# WHITE LAKE TOWNSHIP PLANNING COMMISSION

## REPORT OF THE COMMUNITY DEVELOPMENT DEPARTMENT

**RE:** New Hope – 450 S. Williams Lake Road  
Landscape Modifications

DATE: 10/05/20  
DRAWN: ACA  
CHECKED: JT  
SCALE: 1"=40'  
JOB NO: TED-NHWL  
SHEET TITLE:  
LANDSCAPE PLAN - WEST SHEET  
**L1.0**

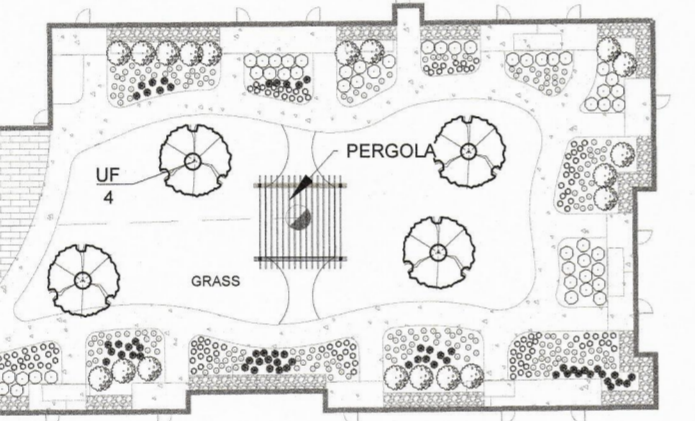
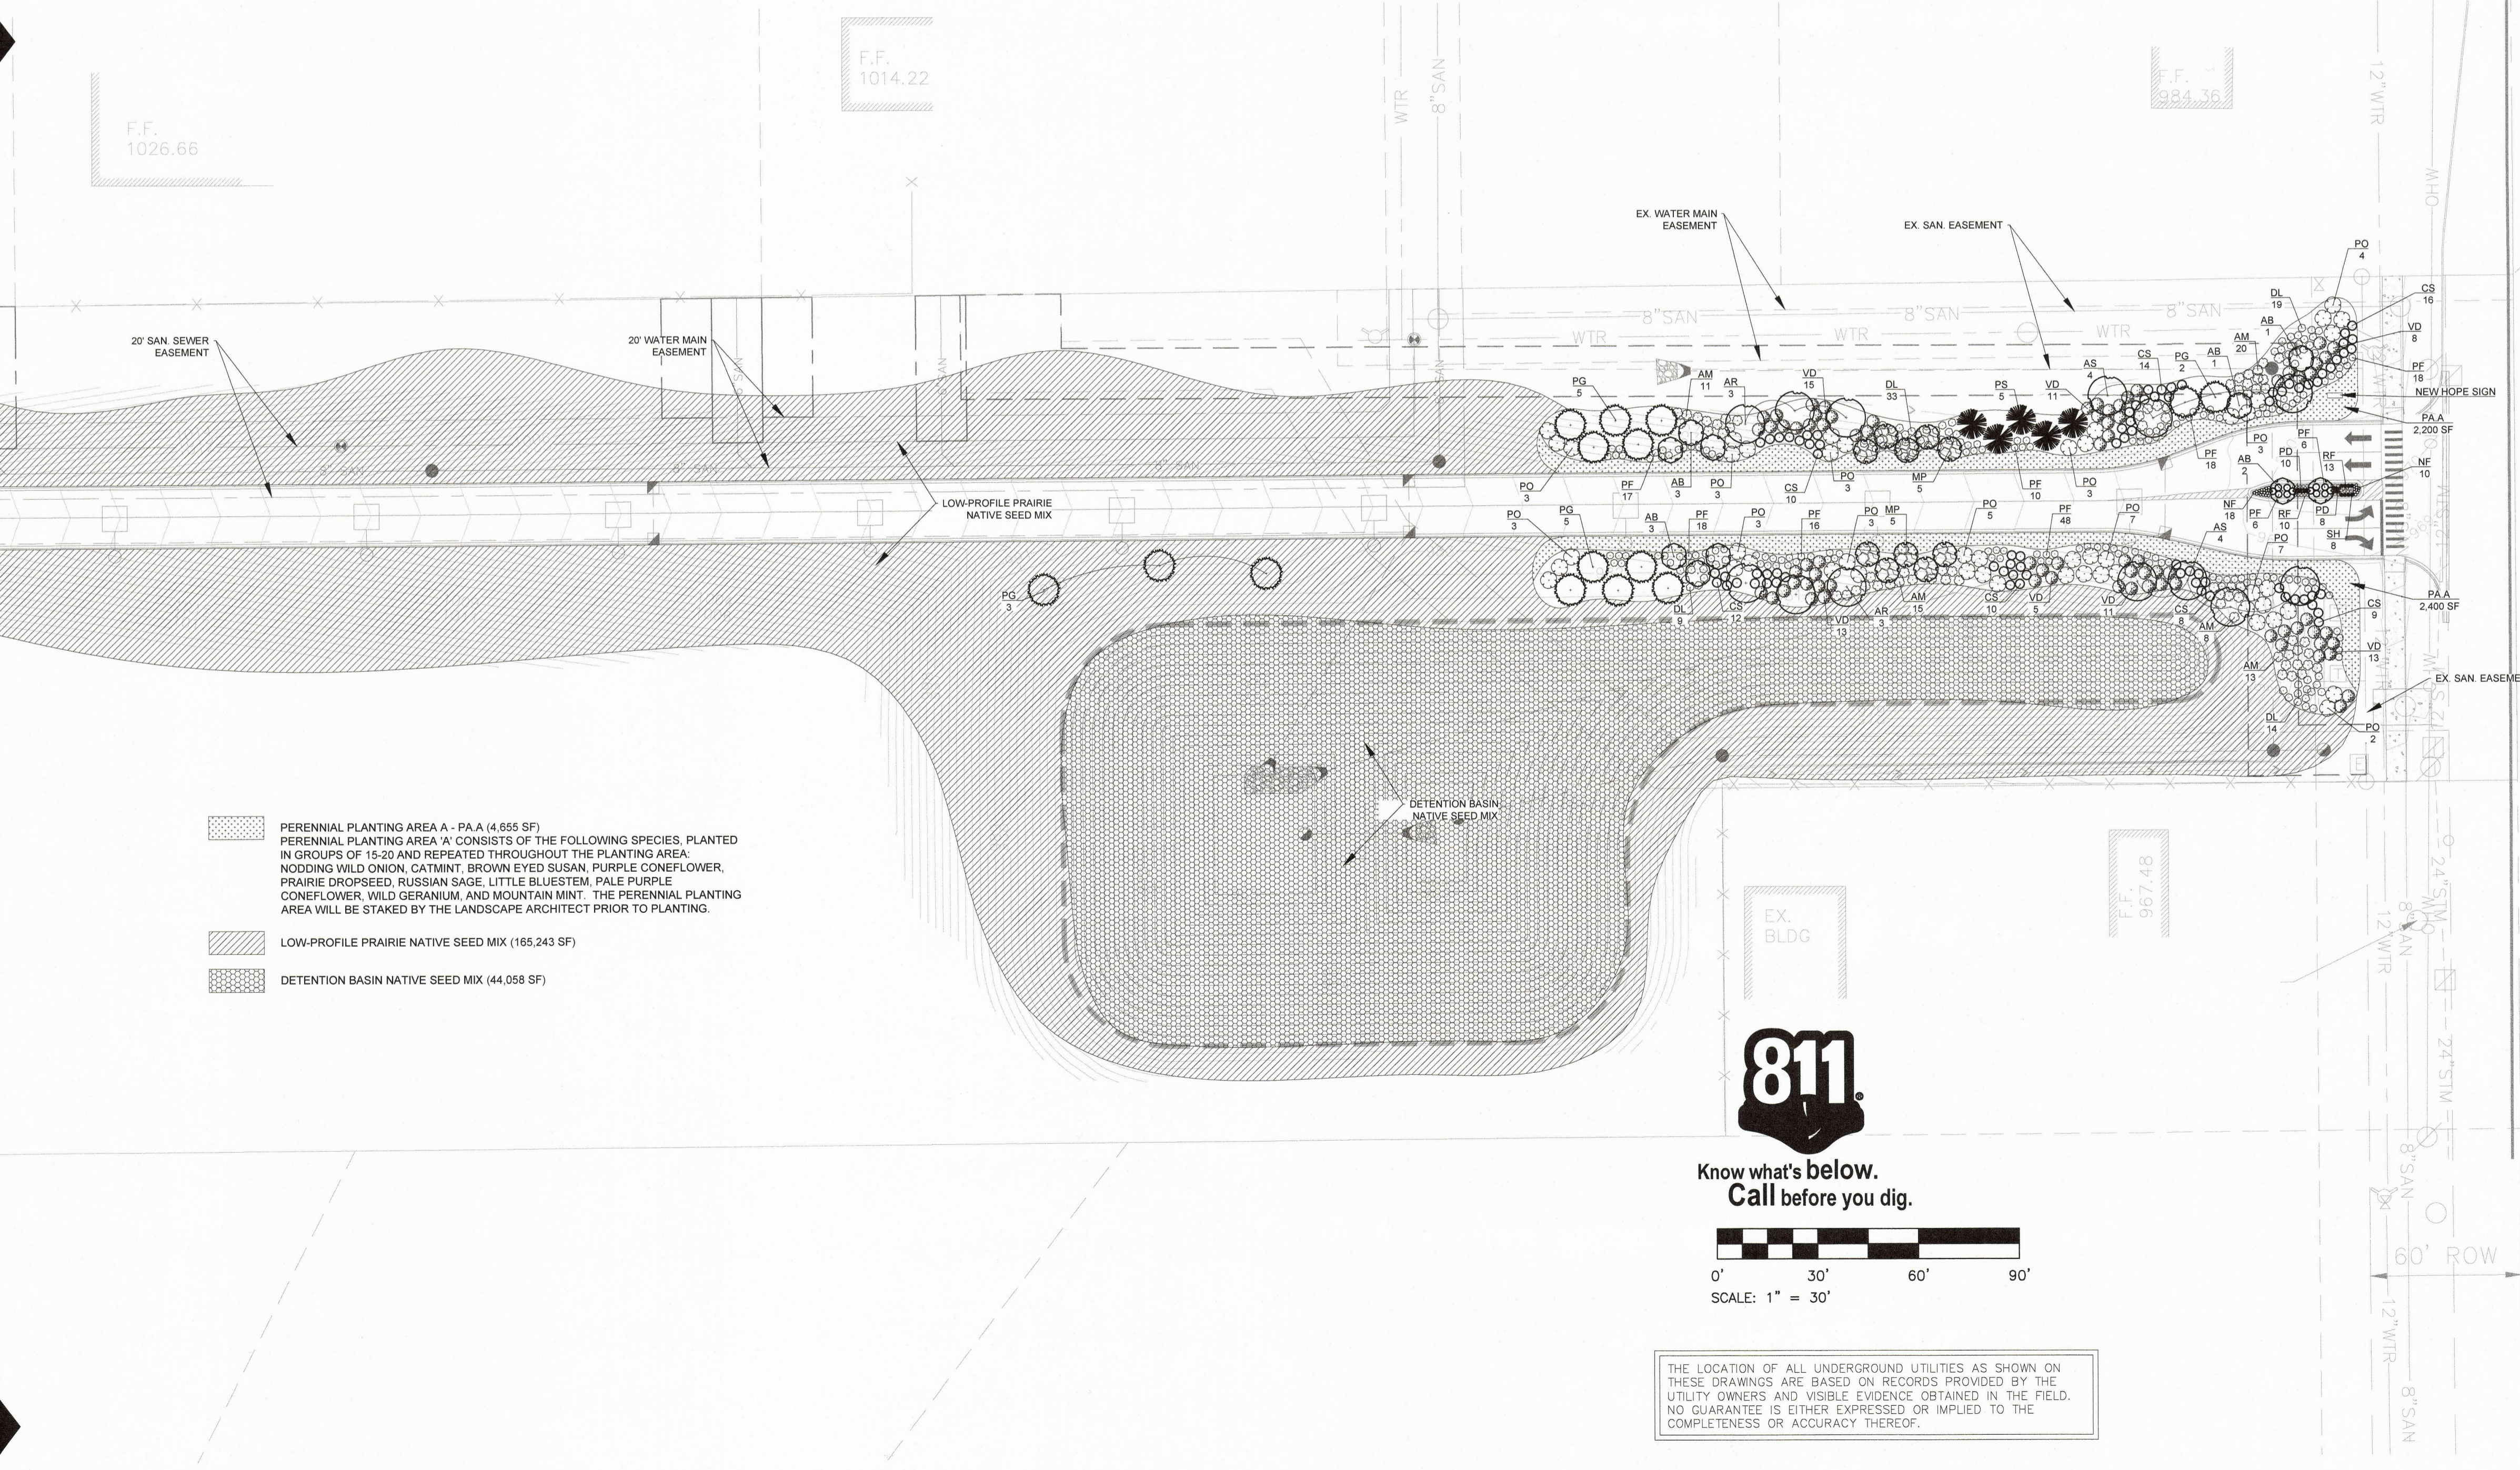
On July 16, 2020 the Planning Commission granted New Hope final site plan approval. The landscape plan presented with the final site plan was included in the approval. At this time, the applicant, Rumi Shahzad, is requesting that the Township allow a reduction in the required landscaping. An as-built landscape plan has been submitted which shows the landscaping currently installed on the site. In comparison to the approved landscape plan, the as-built plan shows an approximate sixty (60) percent reduction in plant material. At their October 6, 2022 meeting, the Planning Commission recommended that the Township Board allow a forty (40) percent reduction in plant material, which will require the applicant to plant twenty (20) percent more material than is currently on site.

DATE:	9/1/22
DRAWN:	ACA
CHECKED:	JT
SCALE:	1"=40'
JOB NO:	TEJ-NHWL
SHEET TITLE:	LANDSCAPE PLAN - WEST
SHEET	
<b>L1.0</b>

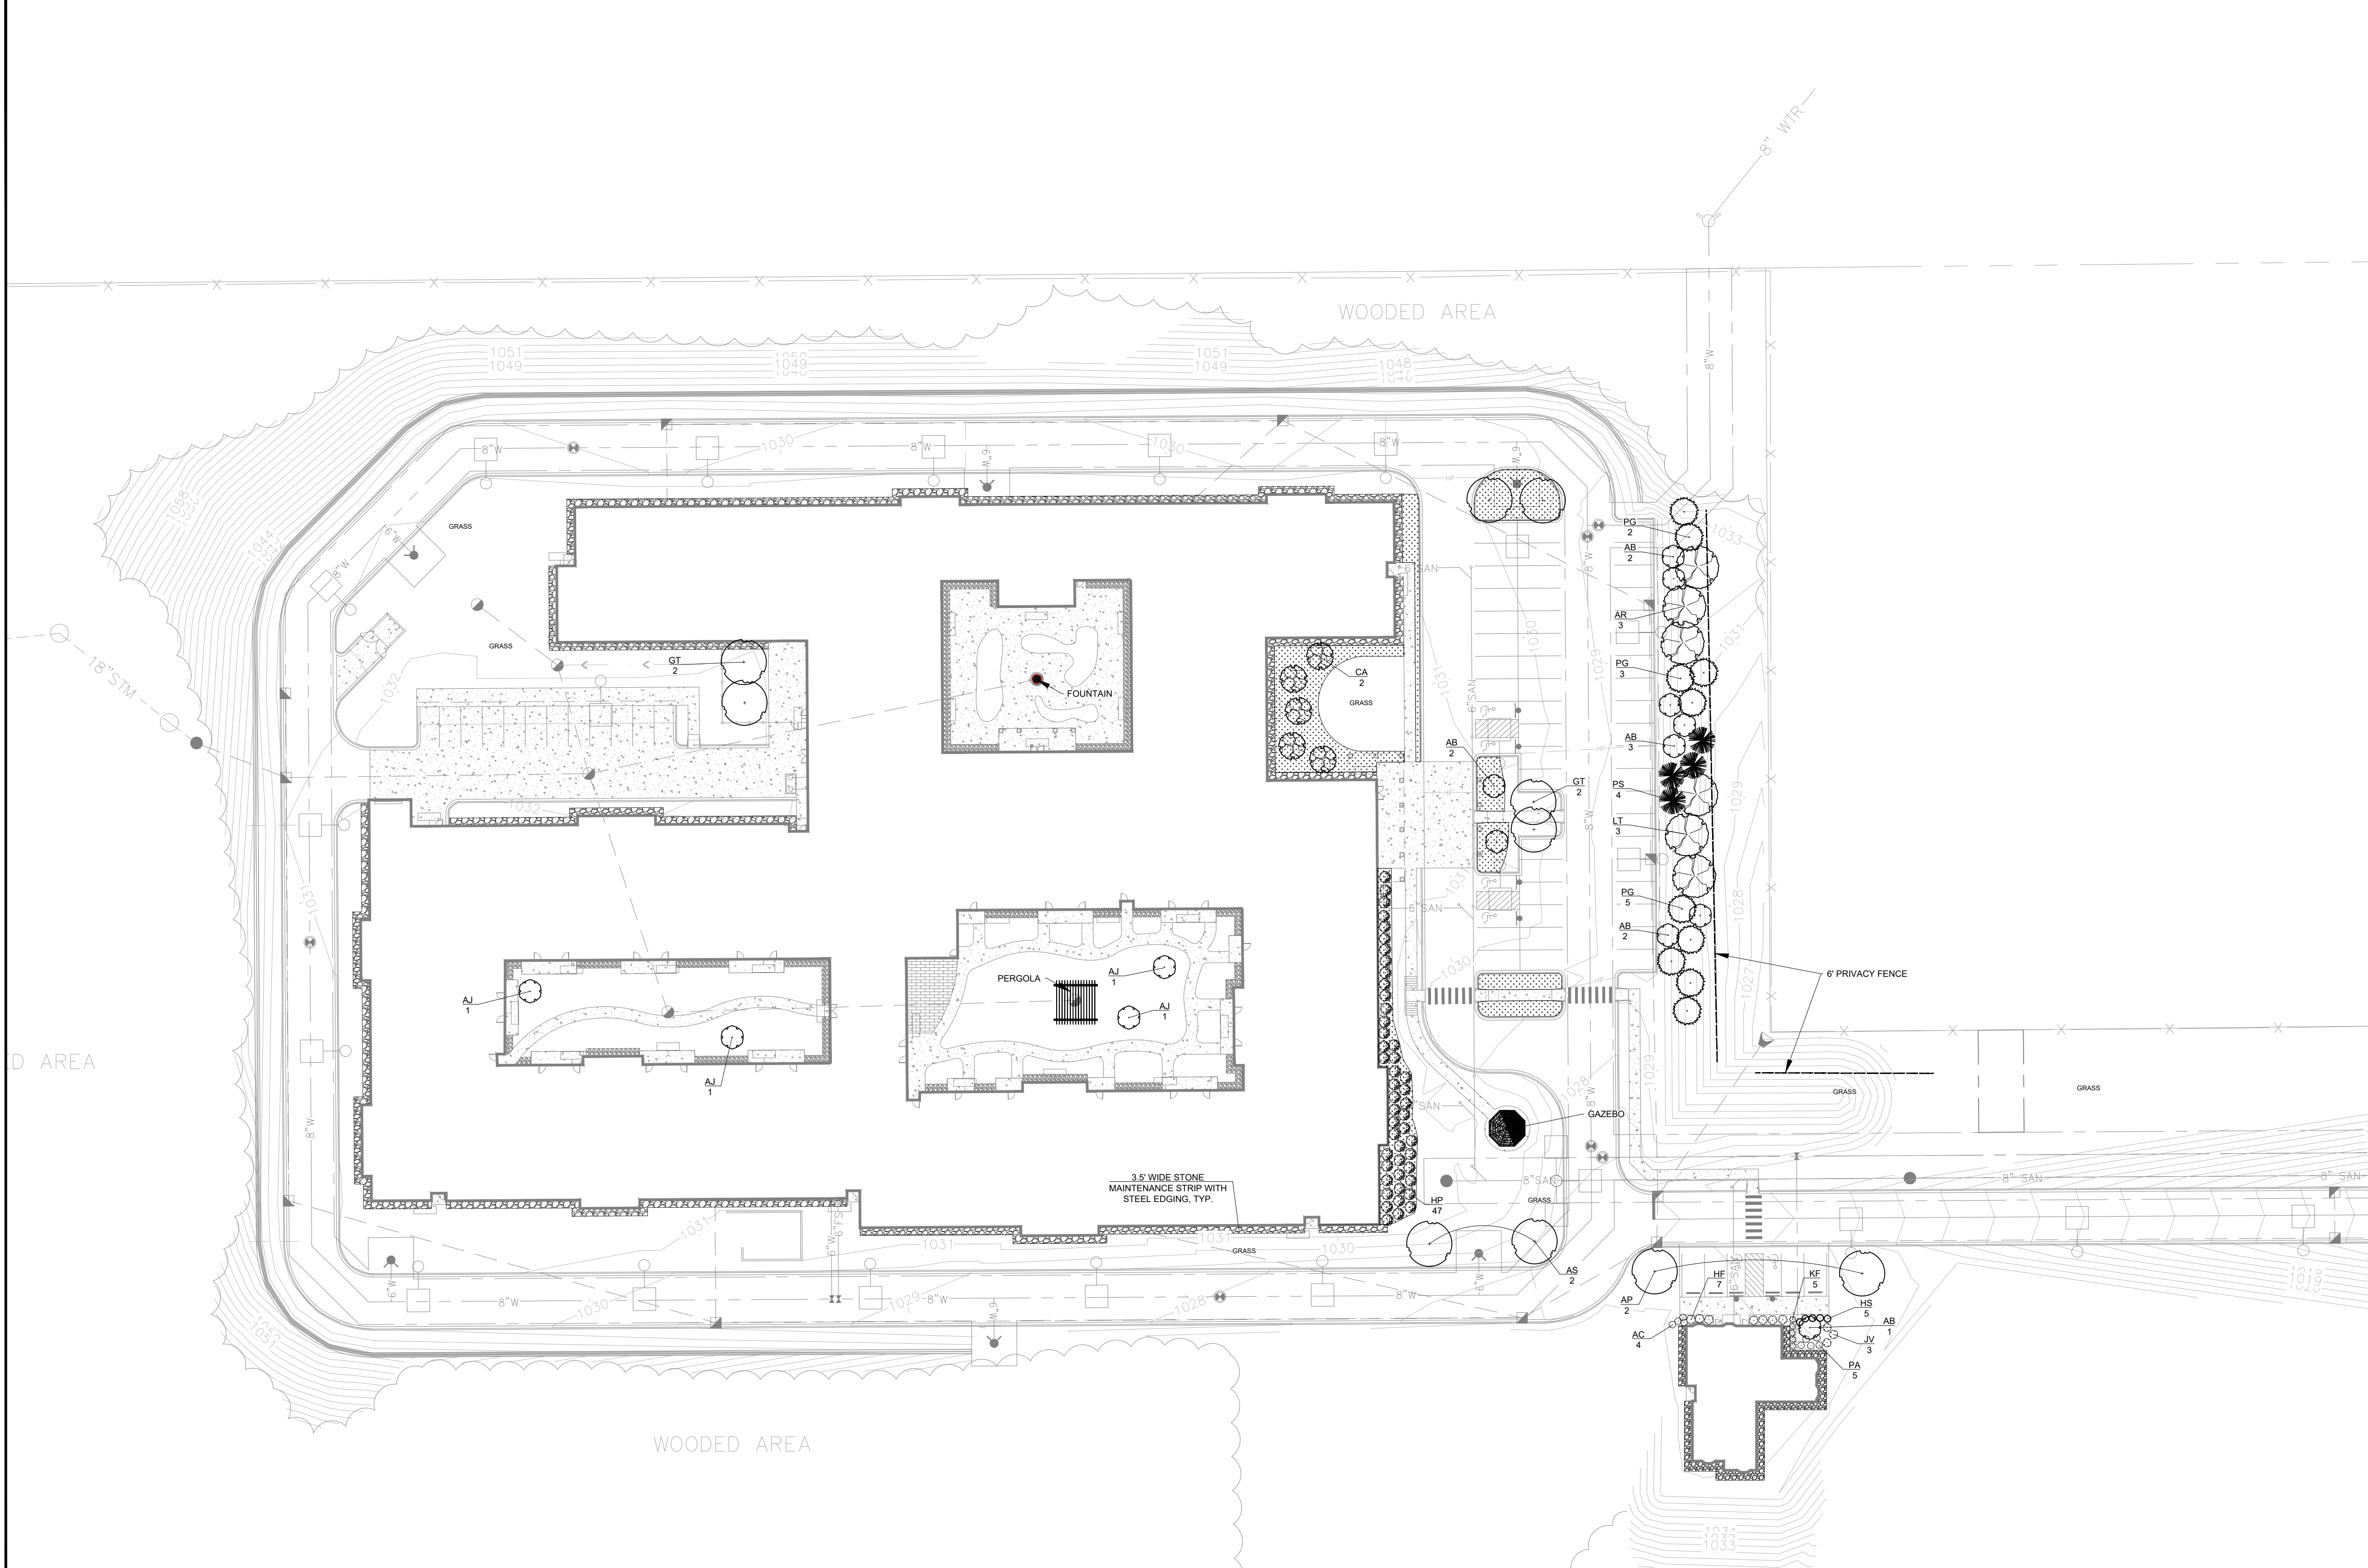
INTERIOR LANDSCAPING REQUIREMENTS  
TOTAL LOT ARE = 21.57 AC; 939,589 SF  
INTERIOR LANDSCAPING REQUIRED: 13% OF TOTAL LOT AREA. 959,589\*15=140,938.  
INTERIOR LANDSCAPING PROVIDED: 732,959 SF  
INTERIOR LANDSCAPING TREE REQUIRED (1 PER 300 SF OF REQUIRED AREA): 140,938/300 = 470 TREES  
INTERIOR LANDSCAPING SHRUBS REQUIRED (5 PER 300 SF OF REQUIRED AREA): 140,938/300\*5 = 2,349 SHRUBS  
\*DUE TO THE HEAVILY WOODED NATURE OF THIS SITE, A MAJORITY OF THE SITE IS BEING LEFT UNDISTURBED AND THE LANDSCAPE AREA SQUARE FOOTAGE AND TREE AND SHRUB REQUIREMENTS ARE LARGELY MET BY UTILIZING THE EXISTING SITE FEATURES. AS A PART OF THE CONSTRUCTION AGREEMENT, THESE WOODLAND AREAS WILL BE PROTECTED AND WILL NOT BE DEVELOPED IN THE FUTURE, ENSURING THIS SCREEN WILL REMAIN IN THE FUTURE.  
\*\* IN ADDITION TO THE EXISTING TREES AND SHRUBS ON-SITE, THIS PLAN PROPOSES TO PLANT AN ADDITIONAL 88 TREES AND 50 SHRUBS.

**AS-BUILT NOTE**  
THIS LANDSCAPE PLAN IS TO SERVE AS AN AS-BUILT DRAWING BASED ON THE ACTUAL LANDSCAPE MATERIALS WHICH WERE INSTALLED BY BELL LANDSCAPING AT THE DIRECTION OF THE OWNER. THIS DRAWING IS BEING PROVIDED TO ADDRESS DIFFERENCES BETWEEN THE APPROVED LANDSCAPE PLAN WHICH WAS SUBMITTED ON 10/5/20, AND THE MATERIALS AND QUANTITIES WHICH WERE ACTUALLY INSTALLED ON-SITE. LANDSCAPING LOCATION, SPECIES, AND QUANTITIES PROVIDED BY BELL LANDSCAPING AND ARE REFLECTED ON THIS PLAN. ALL PLANT MATERIALS AND INSTALLATION TO BE IN COMPLIANCE WITH THE INFORMATION AND SPECIFICATIONS PROVIDED IN THE LANDSCAPE PLAN, REGARDLESS OF INSTALLATION STATUS.

THE LANDSCAPE QUANTITIES, SPECIFICALLY TREE AND SHRUB NUMBERS, ARE LESS THAN WHAT IS REQUIRED BY THE ZONING ORDINANCE. HOWEVER, DUE TO THE AMOUNT OF WOODLAND AREAS SURROUNDING THE PROPERTY, AND THE TOPOGRAPHY AROUND THE PERIMETER OF THE SITE, THE CLIENT IS REQUESTING THAT THE PRESERVED WOODLANDS COUNT TOWARDS THE TREE AND SHRUB TOTALS TO BRING THE LANDSCAPE PLAN INTO COMPLIANCE WITH THE ZONING ORDINANCE.
